PAGES TO BE AMENDED

viii	3/4.5-17
1.0-2	3/4.5-18
1.0-5	3/4.5-19 (deletion)
1.0-6	3/4.5-20 (deletion)
1/2.1-1	3/4.5-21 (deletion)
1/2.1-2	3/4.5-22
1/2.1-3	3/4.5-23 (replaced with two figures)
1/2.1-4	3/4.5-24
B1/2.1-7	3/4.5-25
B1/2.1-8	3/4.5-26
B1/2.1-12	3/4.5-27
B1/2.1-14	3/4.5-28 (replaced with single figure)
3/4.1-1	3/4.5-29
3/4.1-2	B3/4.5-34
B3/4.1-20	B3/4.5-37
3/4.2-12	B3/4.5-38
3/4.2-13	B3/4.5-39
3/4.3-11	B3/4.5-42
3/4.3-19	3/4.6-15
B3/4.3-20	3/4.6-16
3/4.5-8	B3/4.6-36
3/4.5-9	B3/4.6-37
3/4.5-15	3/4.10-8
3/4.5-16

The Technical Specifications contained in Appendix A, as revised through Amendment ^{TBD} 98 are hereby incorporated in the license. The licensee shall operate the facility in accordance with the Technical Specifications.

Figure 3.5-1
(Sheet 2 of 8)

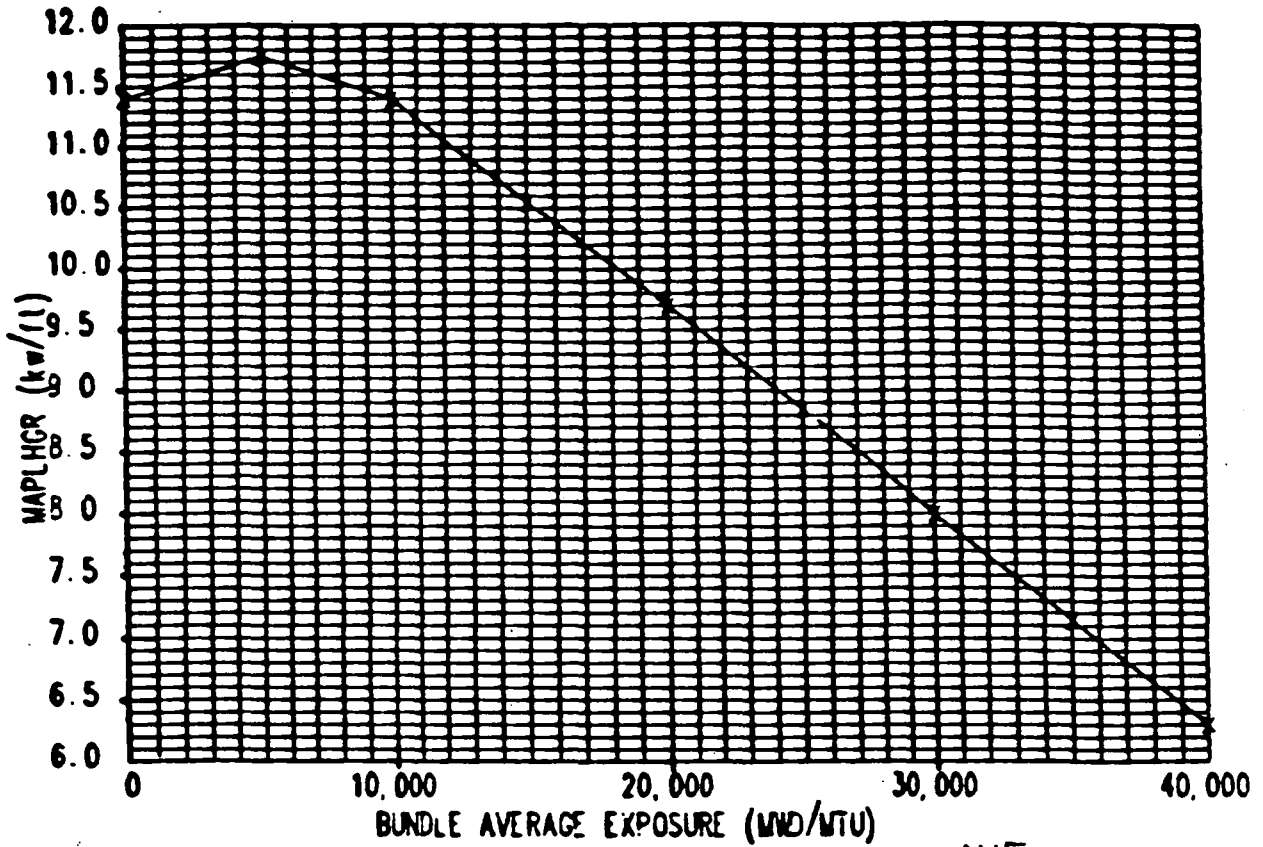
The above graph is based on the following MAPLGR summary for ^{ANF} ENC 9x9 fuel design:

Figure 3.5-1
(Sheet 3 of 6)

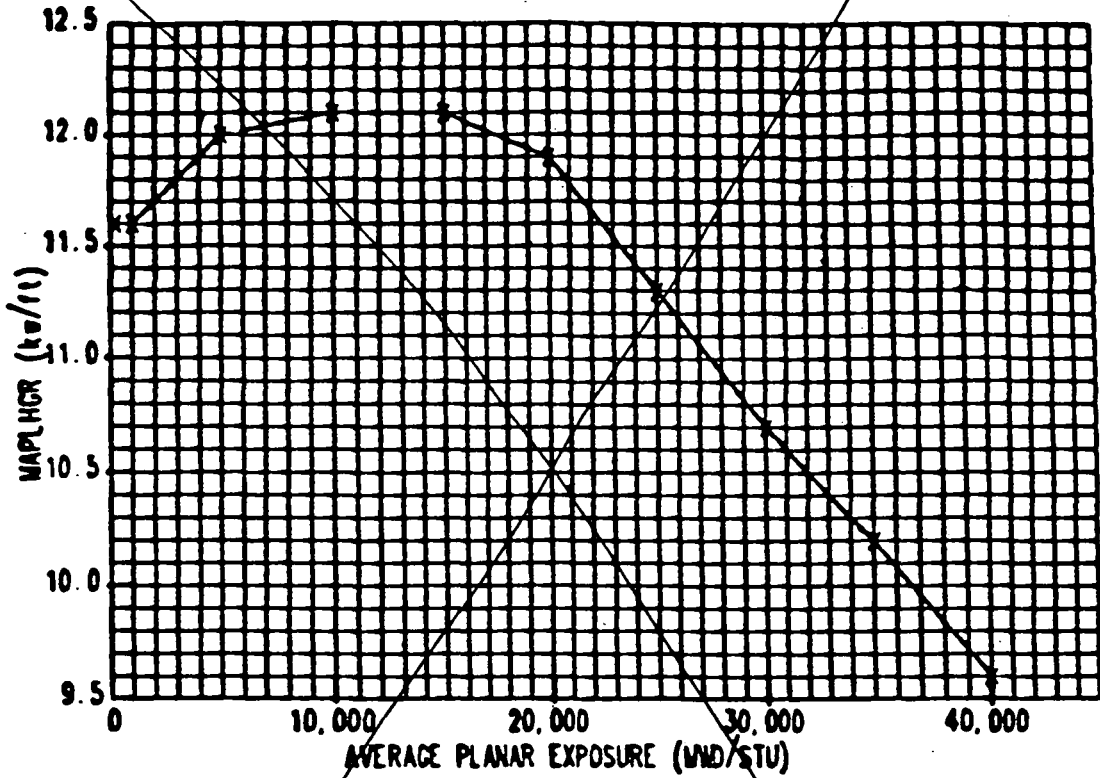
Delete this figure

Figure 3.5-1
(Sheet 4 of 6)

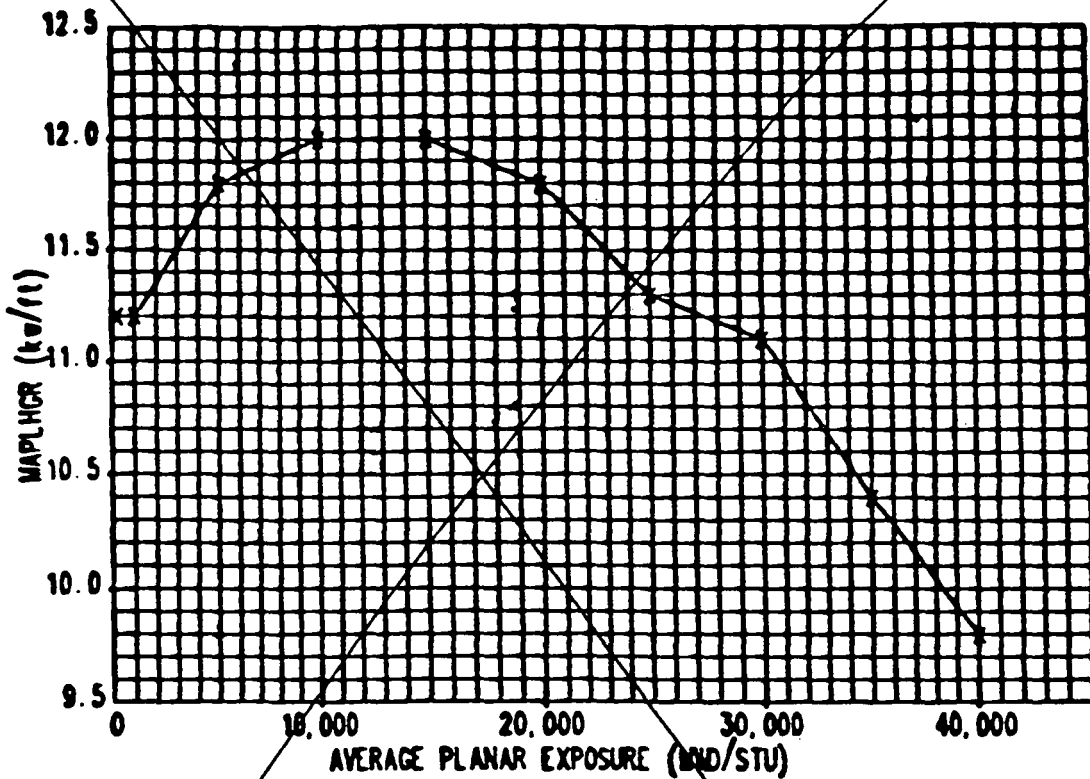
delete this figure

Figure 3.5-1
 (Sheet 5 of 6)

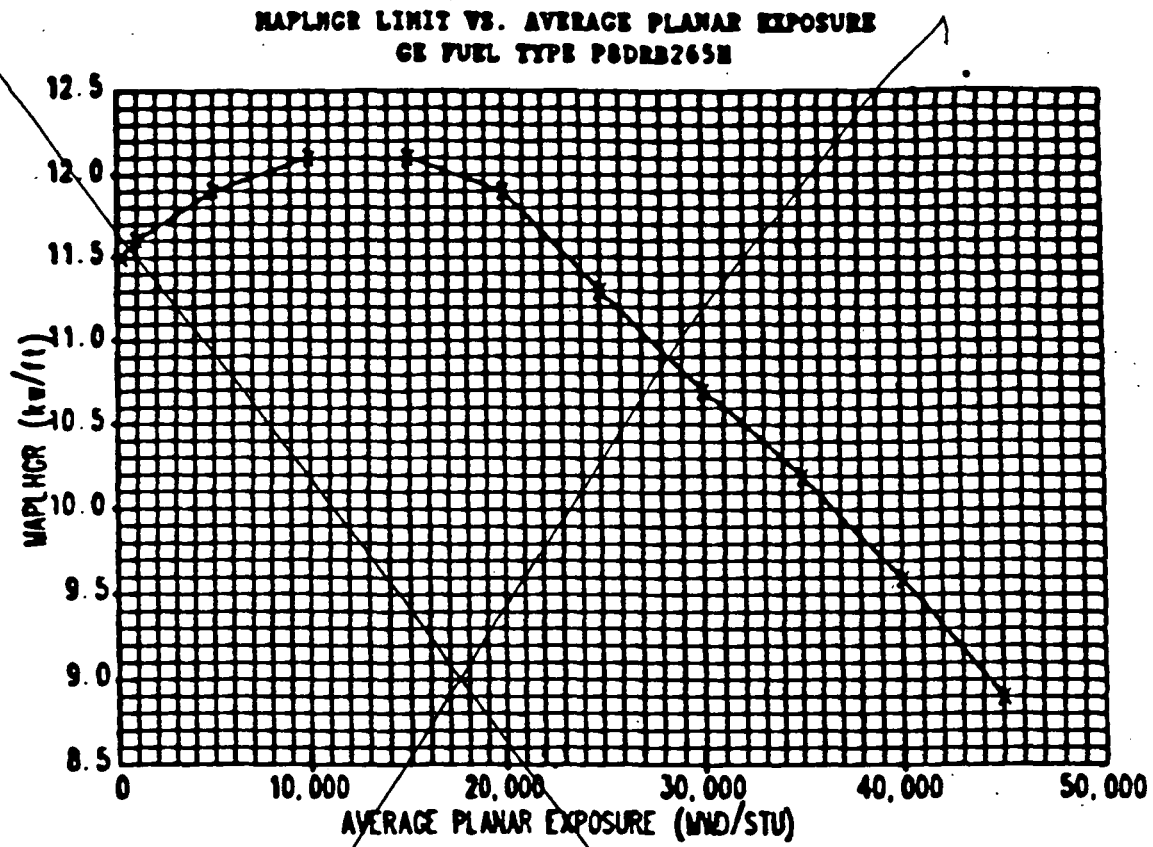
delete this figure

Figure 3.5-1
(Sheet 3 of 3)
3/4.5-22

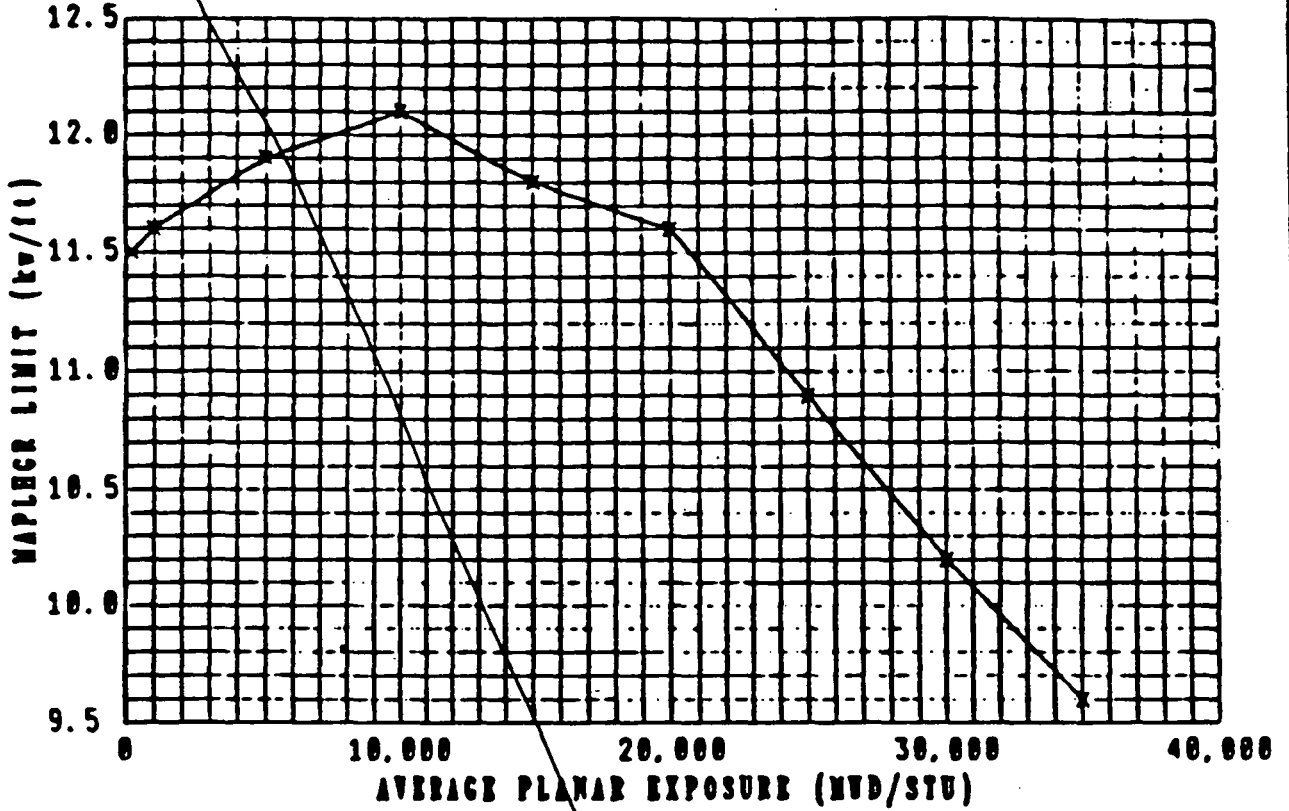
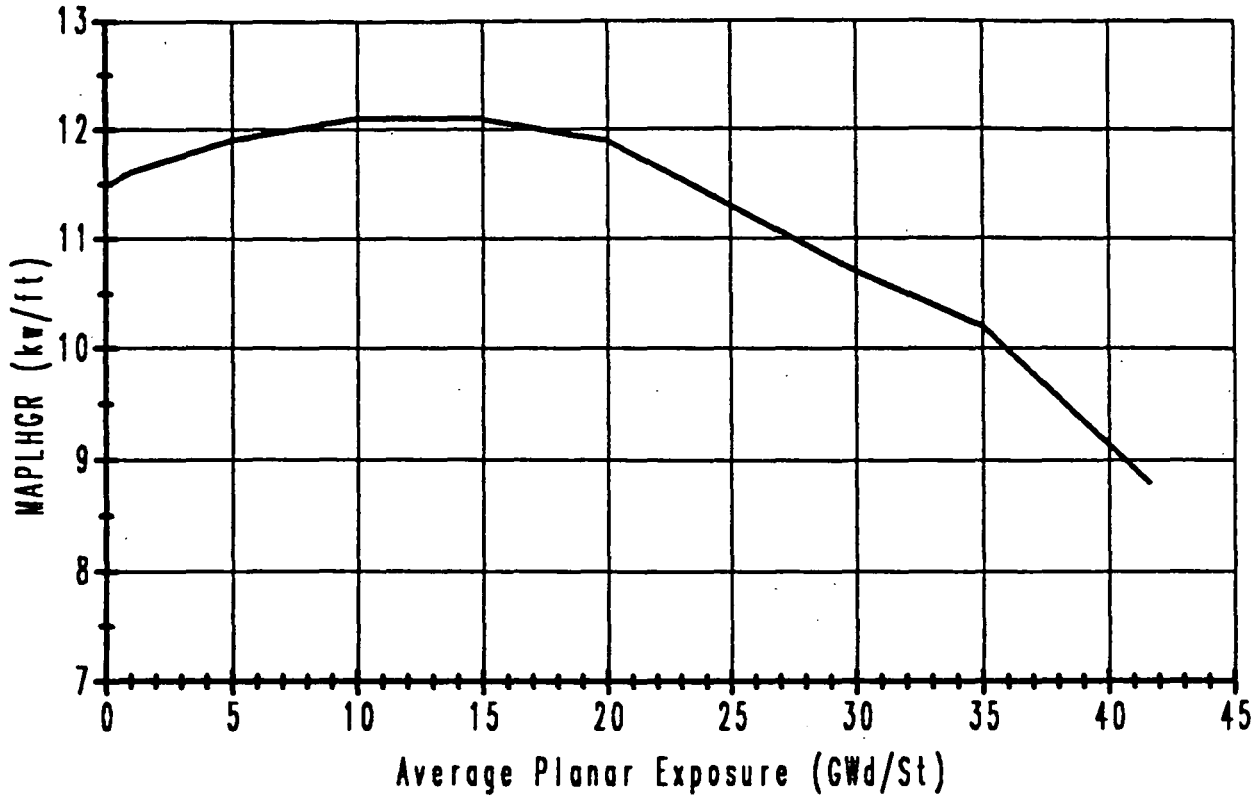
replace with Insert JJ

Insert JJ

MAPLHGR Vs. Average Planar Exposure GE 8x8 LTAs

The above graph is based on the following bounding
MAPLHGR summary for the GE LTAs.

Average Planar Exposure (GWd/St)	MAPLHGR (KW/FT)
0.2	11.5
1.0	11.6
5.0	11.9
10.0	12.1
15.0	12.1
20.0	11.9
25.0	11.3
30.0	10.7
35.0	10.2
41.6	8.8

Figure 3.5-1A

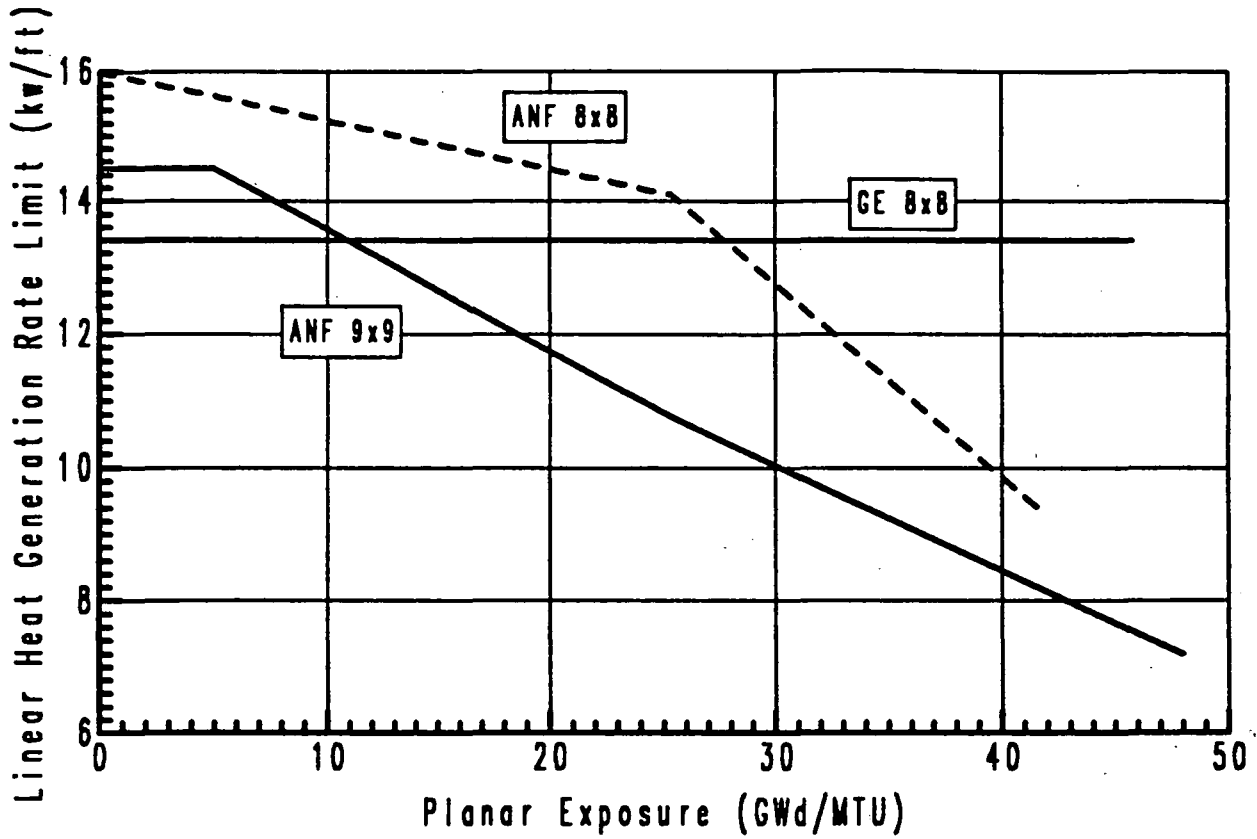
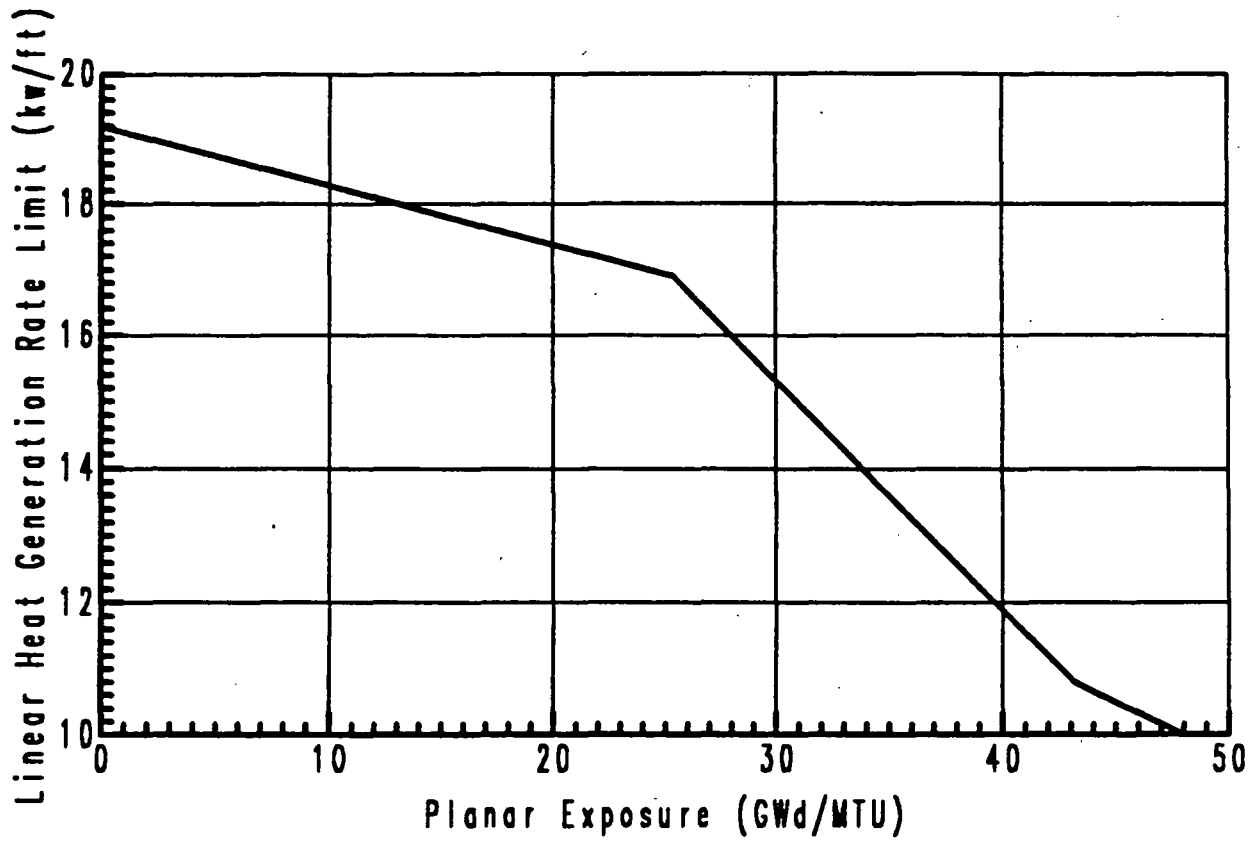
replace with
Insert K and
Insert L.

Insert L

TRANSIENT LINEAR HEAT GENERATION RATE LIMIT (TLHGR)
VS. NODAL EXPOSURE FOR ALL ANF FUEL

Figure 3.5-1B

Figure 3.5-2 (Sheet 2 of 3)
 GE and Exxon 8x8 MCPR Operating Limit For Automatic Flow Control

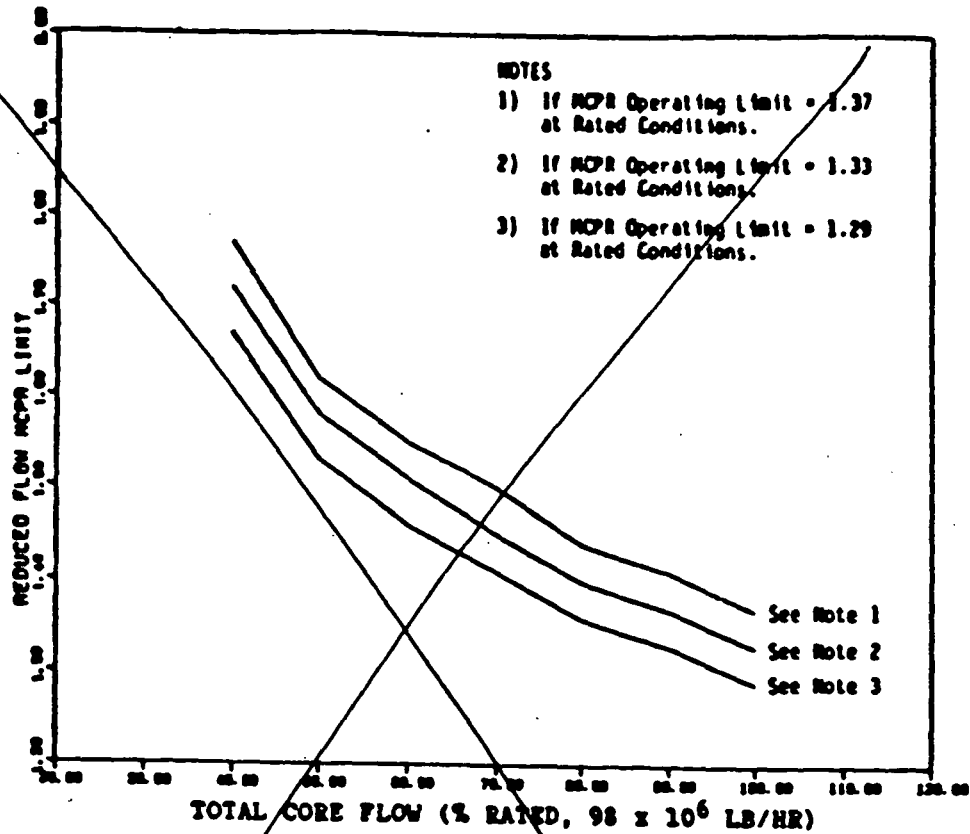
*replace with
 insert m*

Figure 3.5-2 (Sheet 3 of 3)
 Exxon 9x9 MCPR Operating Limit For Automatic Flow Control

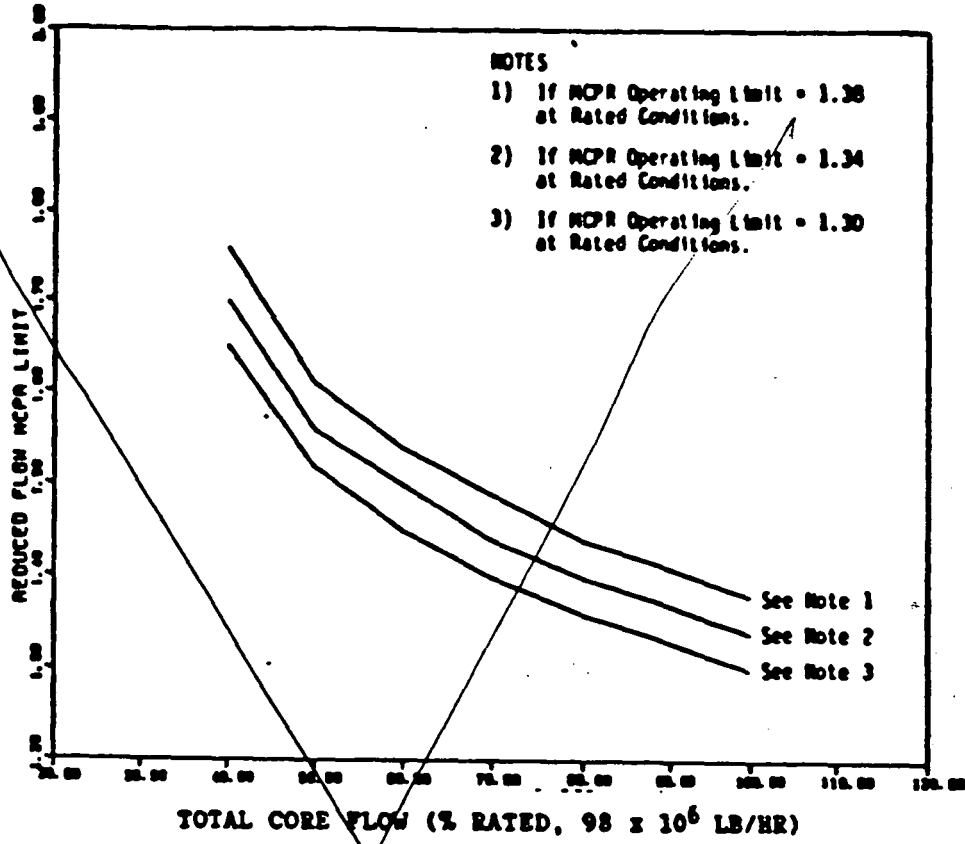
(replace with insert N)
